ADDENDUM 2 FOR RFQ/RFP NO. BONDS06

PORTABLE SITEWORK AT ADELANTE AND APTITUD

ADDENDUM 1

Project: Aptitud Academy New Portable Classroom Addition
Alum Rock Union School District

E1.0
ELECTRICAL
SITE PLAN

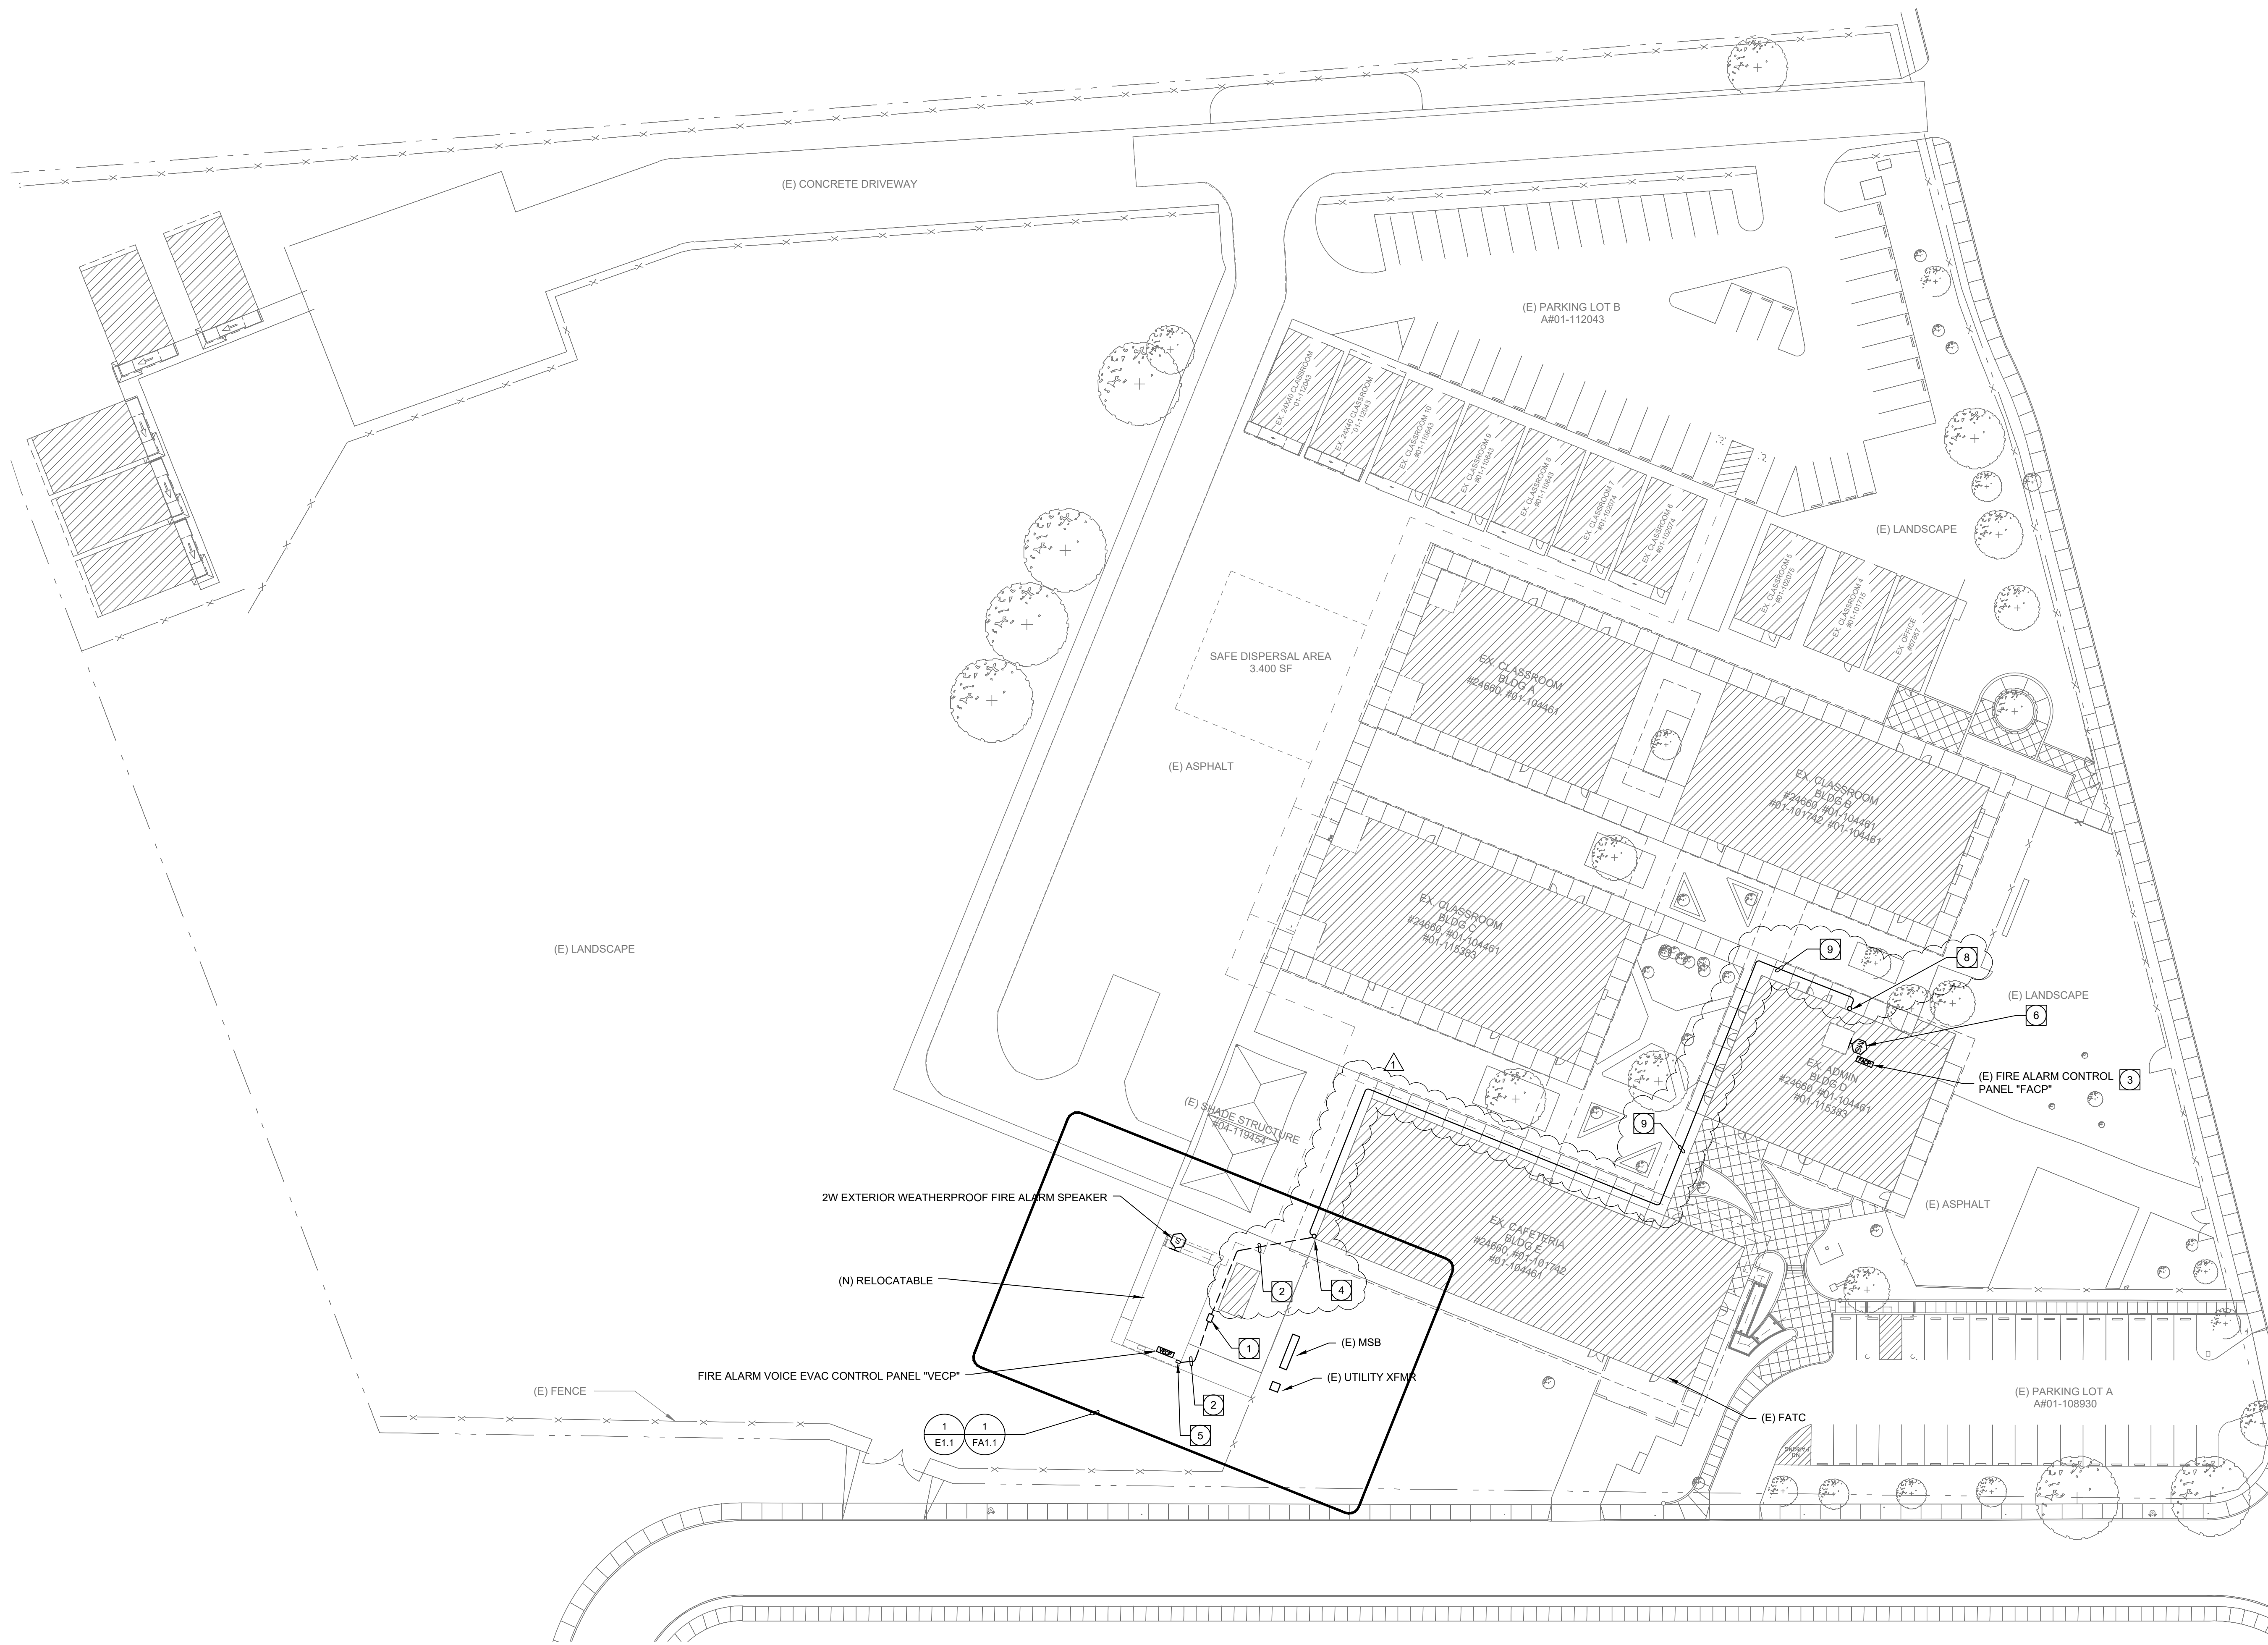
- A. Sheet E01.0 Site Electrical Plan
 - a. Replace sheet E01.0 with the attached Addendum 1 sheet E01.0.
 - b. Description of changes: Revised site routing for fire alarm conduits.

E1.0
ELECTRICAL
SITE PLAN

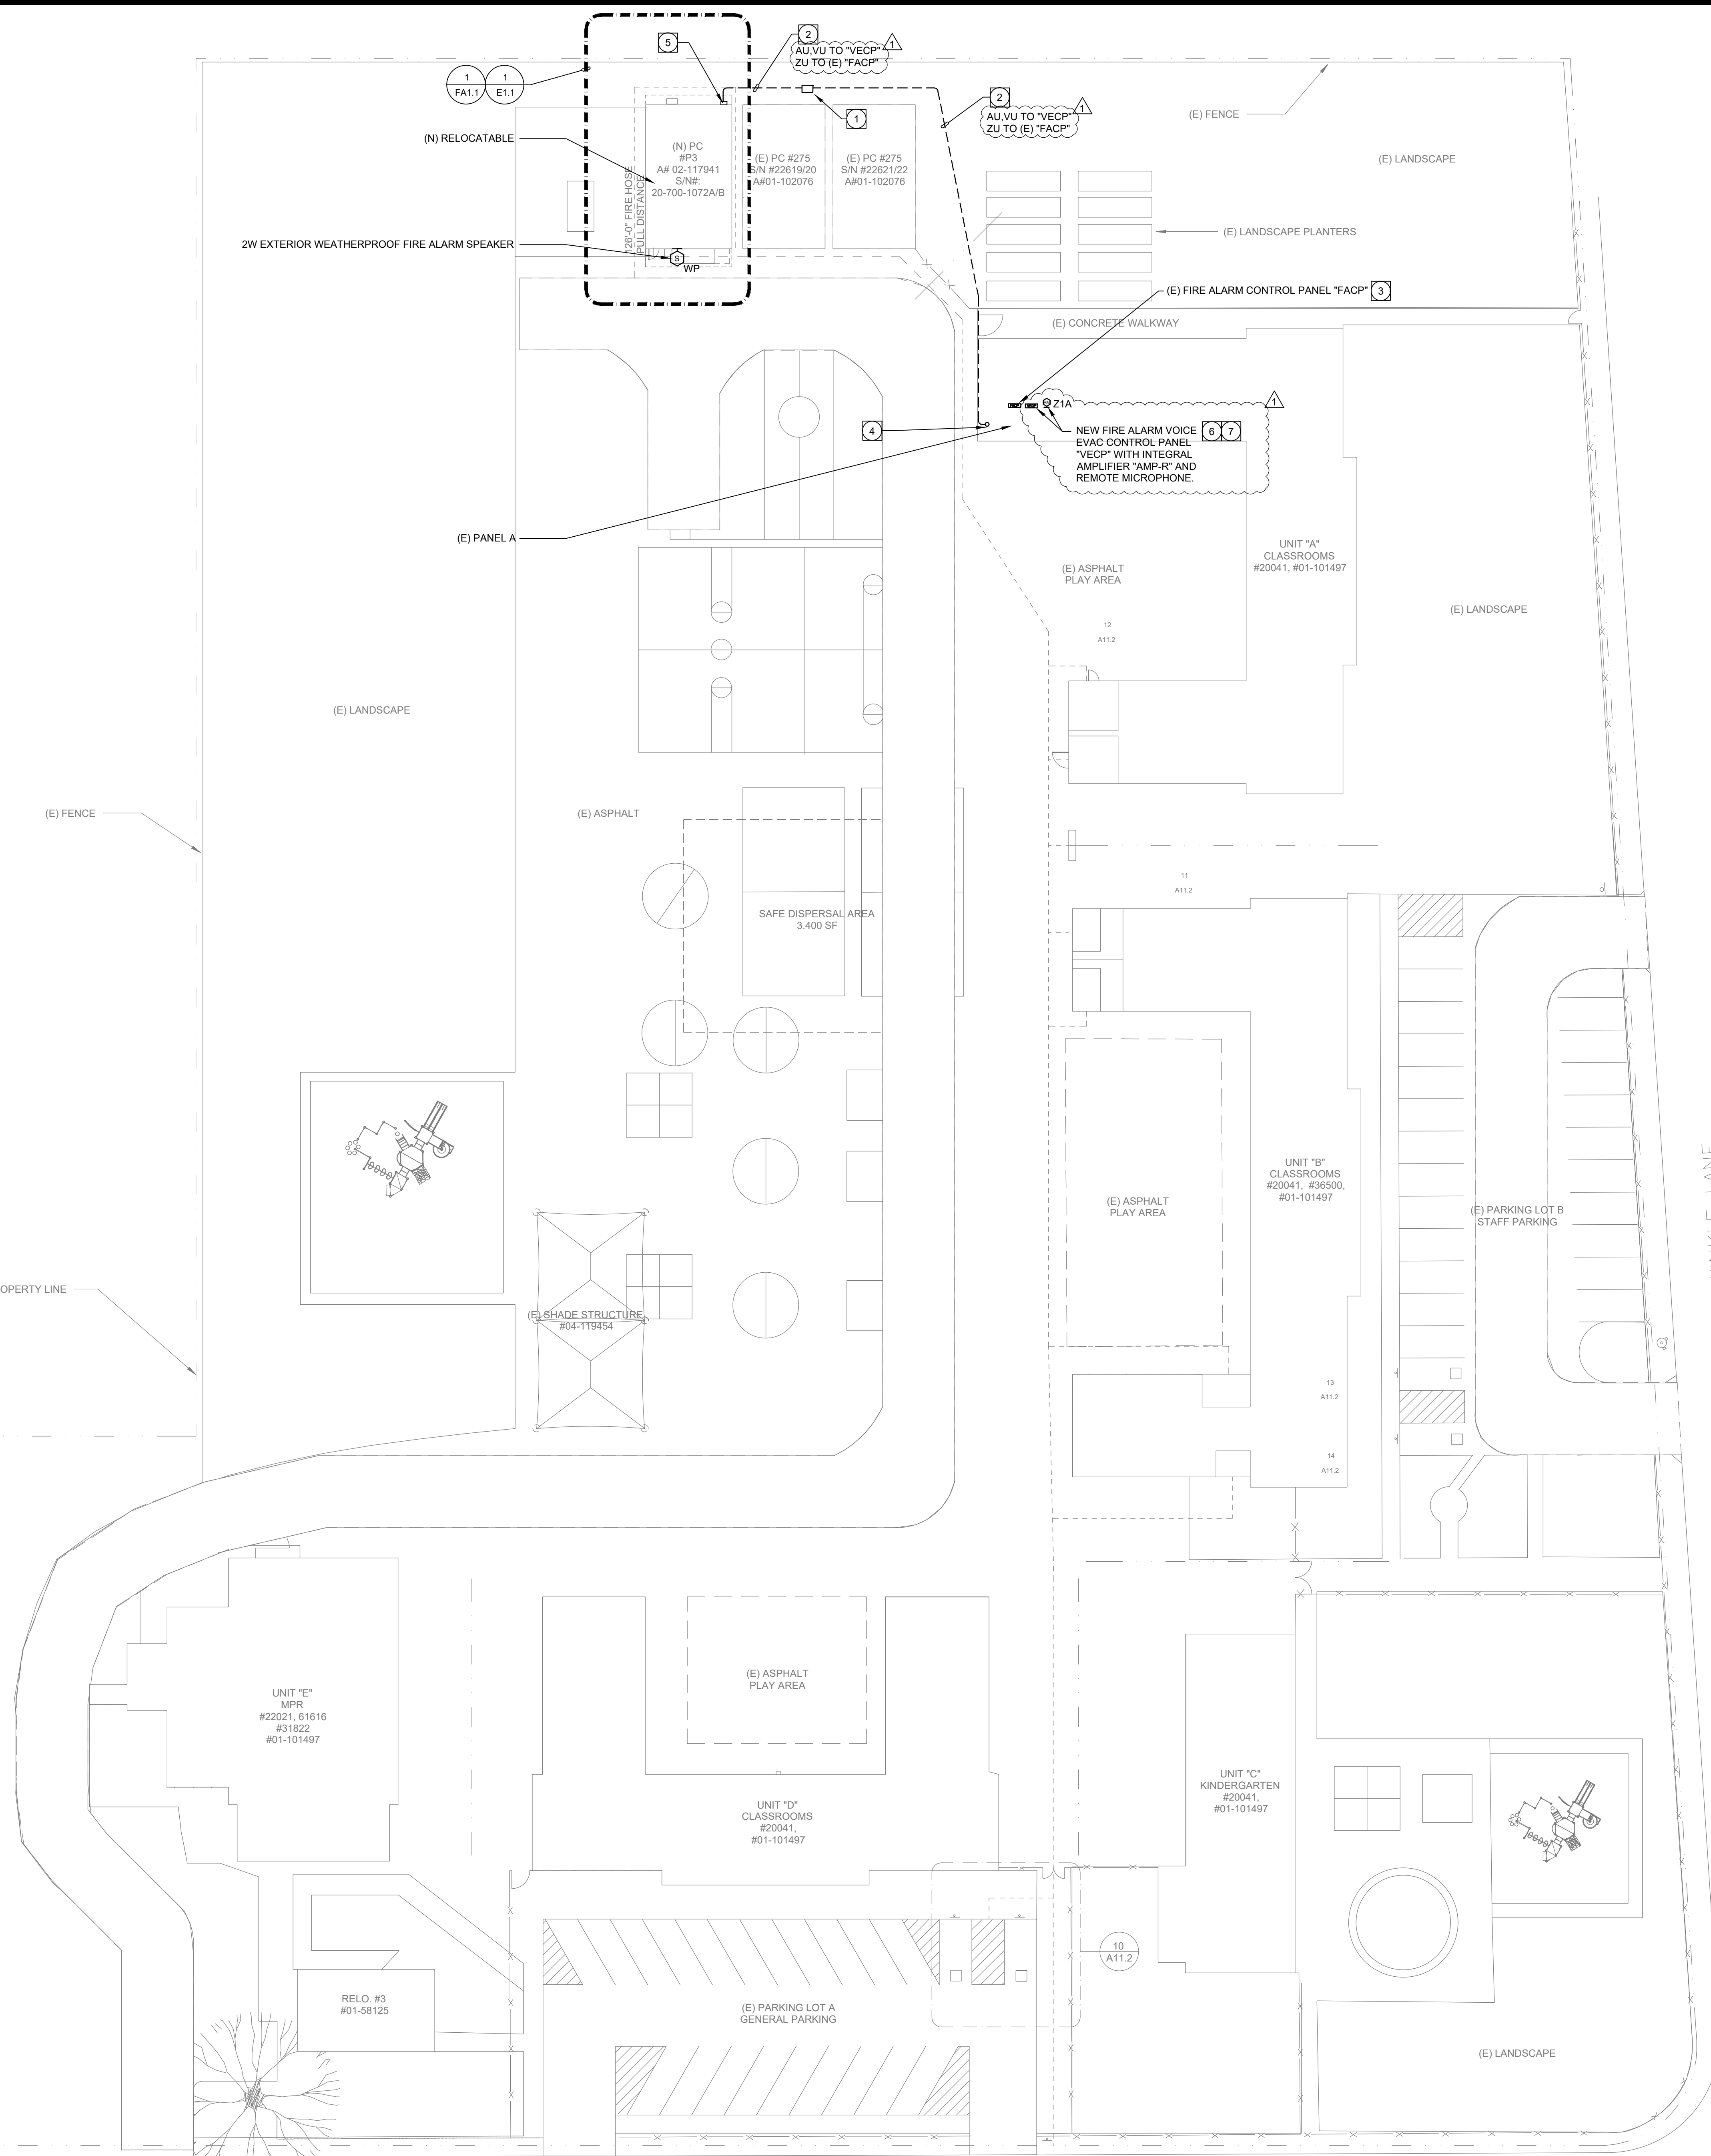
- A. Sheet E01.0 Site Electrical Plan
 - a. Replace sheet E01.0 with the attached Addendum 1 sheet E01.0.
 - b. Description of changes:
 - i. Added conductor information to fire alarm conduit.

- ii. Relocated new fire alarm VECP and remote microphone to admin building.
 - iii. Added Plan Notes 6 & 7.
- B. Sheet FA0.1 Fire Alarm Information
 - a. Replace sheet FA0.1 with the attached Addendum 1 sheet FA0.1.
